**TOWN COUNCIL ACTION ITEM
STAFF SUMMARY
SEPTEMBER 6, 2017 PLANNING AND ZONING COMMISSION MEETING**

Consideration of Resolution No. PZ 10-17, Series of 2017;

A RESOLUTION BY THE PLANNING AND ZONING COMMISSION OF THE TOWN OF DILLON, COLORADO, RECOMMENDING THE APPROVAL OF A LEVEL IV DEVELOPMENT APPLICATION FOR THE CHRISTY SPORTS PLANNED UNIT DEVELOPMENT FOR THE APPROVAL OF A NEW BUILDING AND ASSOCIATED PARKING LOCATED AT 817 U.S. HIGHWAY 6 ON LOT 42R OF THE PTARMIGAN TRAIL ESTATES SUBDIVISION UNIT 1, DILLON, COLORADO; AND, SETTING FORTH DETAILS IN RELATION THERETO.

OFF-STREET PARKING LOT CONSIDERATIONS:

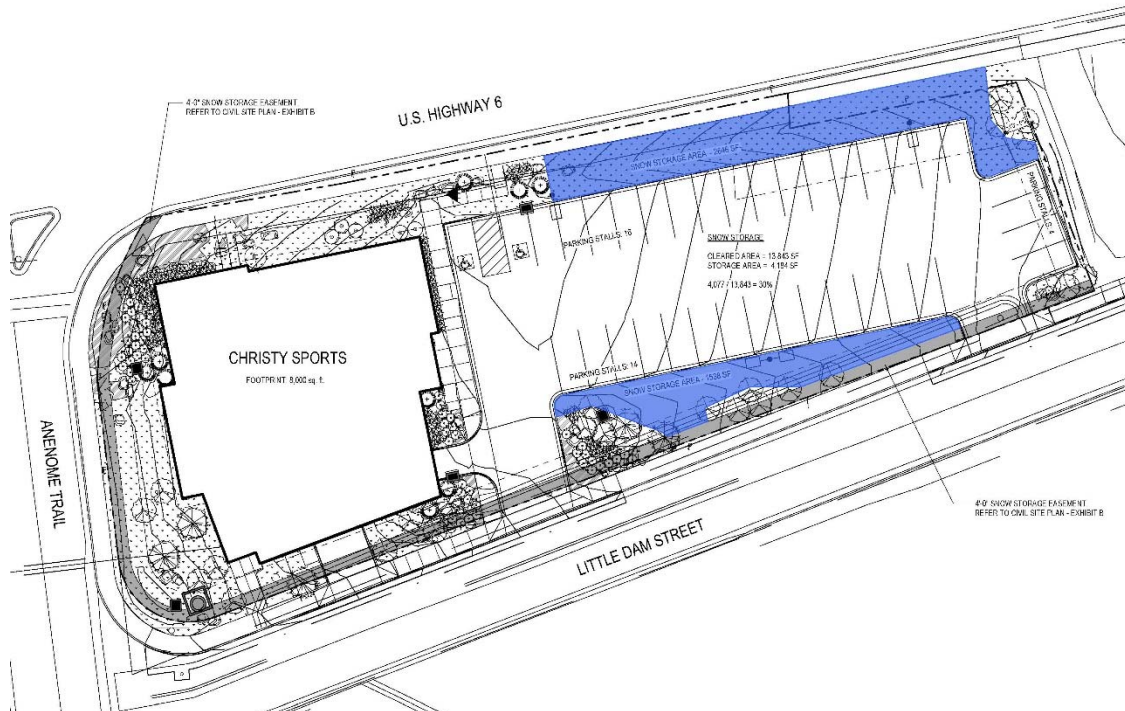
The proposed building is 17,105 square feet. Town code requires one parking space for every 400 square feet of floor area in a commercial/retail building. The Town code requires 43 parking spaces for this development.

The applicant is providing 38 parking spaces including the required two (2) accessible parking spaces, which is 5 spaces fewer than required by Town Code. Through the PUD process, the applicant is allowed to reduce the number of parking spaces when warranted. The applicant believes that their business model only requires 28 parking spaces for the 10,877 square feet of retail floor area ($10877/400=27.2$) and an additional 8 parking spaces for employees; a total of 36 parking spaces. The applicant believes that the 38 parking spaces provided will be adequate.

The maximum proposed grade of a parking lot is at 4%. Because of the nature of the site which runs parallel to Highway 6 and Little Dam Street which have grades in the 5%-6.5% range, the applicant is proposing a parking lot which has a maximum grade of 6%. The applicant believes this is reasonable due to that fact the parking lot will have good sun exposure and won't be shaded by the building. See the attached grading narrative from Redland.
